SUBJ: WING SPAR, Verification of Correct Washers used with Wing Spar Attach Bolts

SAIB: AIR-21-07

Date: March 30, 2021

Piper Washer P/N 96352

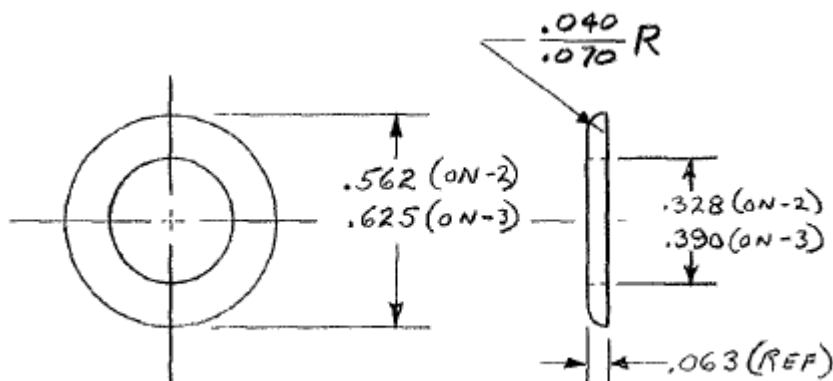
The FAA recommends that any owner/operator ordering and receiving Piper part number 96352-003 (Piper purchase order code 494-284) washers for use in the wing spar attach bolts of any aircraft applicable to AD 2020-26-16 verify that those washers have the required radius on one surface. If the washers do not have the radius as shown below, do not install the wing spar attach bolts until the correct washers are obtained.
